CRS Site Group Response to USEPA August 18 Comments re  
seeps

**Chemical Recovery Systems, Inc. (CRS) Site Group  
Response to E-mailed Comments  
from Gwen Massenburg, RPM, U.S. EPA Region 5  
(Received 18 August 2004)**

Limited water flow  
from 12-inch pipe

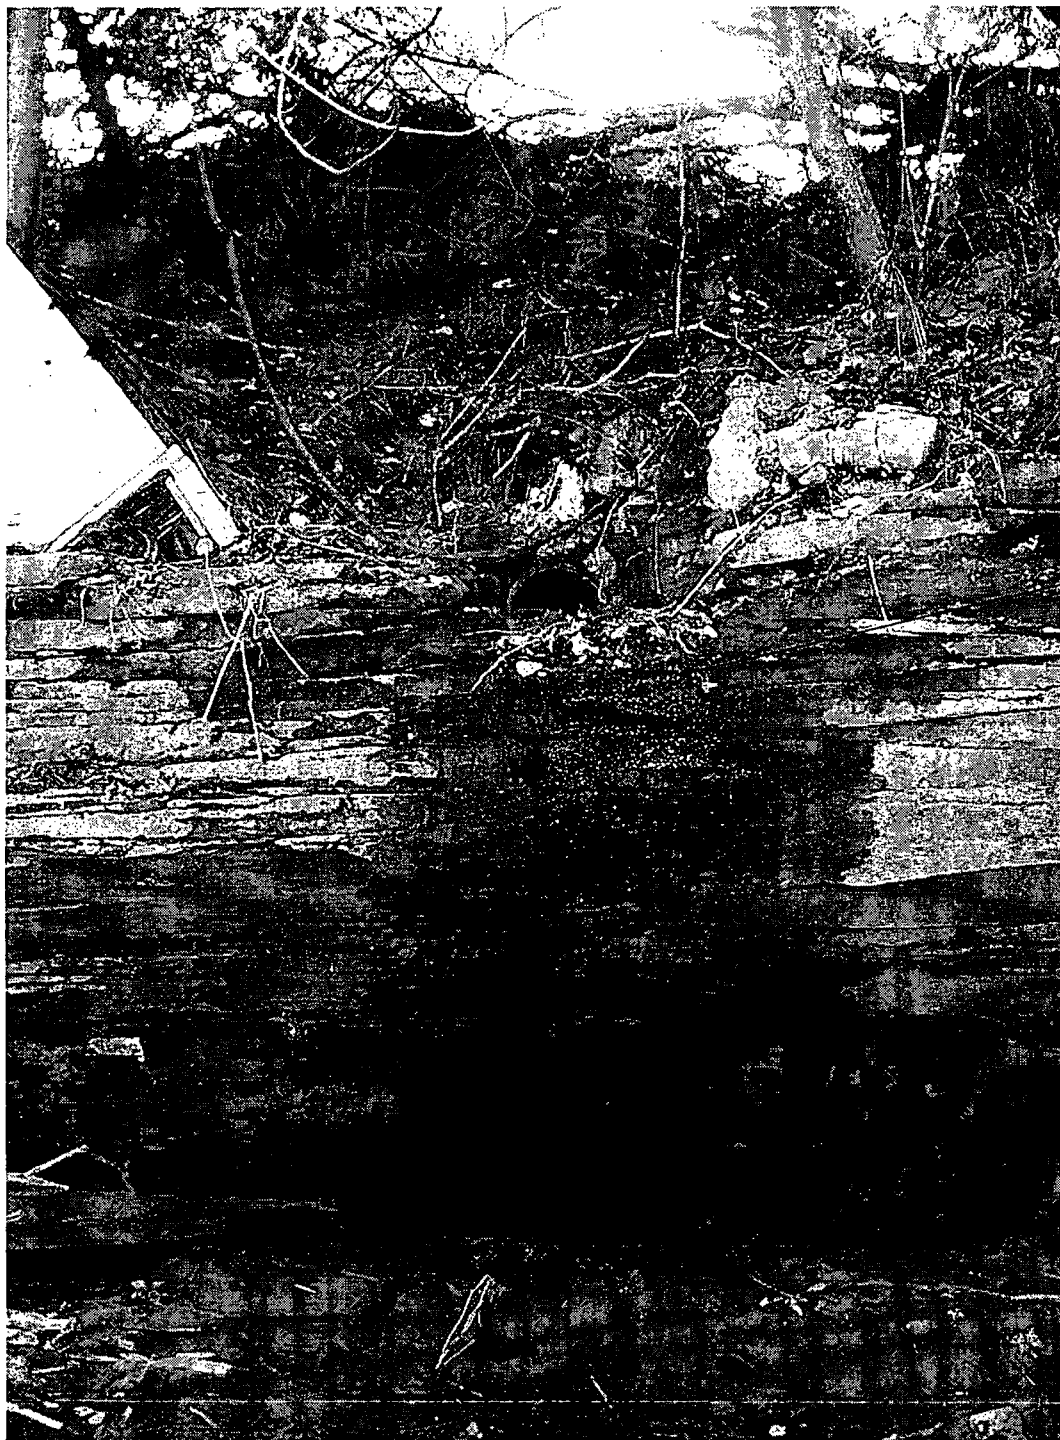
EPA is raising concern over the response to comments relating to potential seeps on the property and on the river bank, see EPA's comments: Section 2.2, Human Health Risk Assessment Summary, page 5 of 20, comment #3, and Section 2.4, page 9 of 20, paragraph 2. EPA does not believe that the issue involving groundwater seepage in the following two locations have been fully characterized and/or evaluated: location one, on the river bank along the northwestern stretch of the site which is covered with concrete debris that was presumably pushed over at some point to stabilize the slope. The bedrock elevation map show bedrock is deeper in that portion of the site, and a small amount of groundwater was encountered in GP-6, and perhaps, someone felt the need to use concrete debris to stabilize the slope, there's a good possibility that seeps are in that vicinity; and location two, there appears to be seepage from the bedding planes in the sandstone as well as discharge from the 12" pipe. See the attached photograph made by EPA's oversight contractor. The response given to EPA states " that no groundwater seeps have been detected at the facility."

EPA request that the areas mention above be evaluated during the human health and the ecologically risk assessment, and too consider the bedding pane seepage during the design phase when you are considering how to finish off the slope.

A site visit was conducted on 23 August 2004 by the Parsons Project Manager and Senior Hydrogeologist and a review of the River bank indicated that there was no free-flowing water emanating from the bedrock and/or slope, other than what can be attributed to the limited flow from or around the circumference of the 12-inch pipe. Water was not observed emanating from beneath the debris associated with "location one." The majority of limited water observed in "location two" can be attributed to the 12-inch pipe (see attached picture). The 12-inch pipe is not the city storm sewer. Moisture was observed in a few bedrock bedding planes, however, there was no free-flowing water and there is not a sufficient quantity of water for sample collection.

The risk assessment will be amended to indicate there is a possibility that there may be a minor unquantifiable volume of water emanating from bedrock and/or slope at the above locations. As the volume of water is unquantifiable, potential exposure to the water will be qualitatively evaluated in the risk assessment. Piping protrusions along the River, with the exception of the city storm sewer, will be addressed in the remedial design and pulled and/or plugged as warranted.
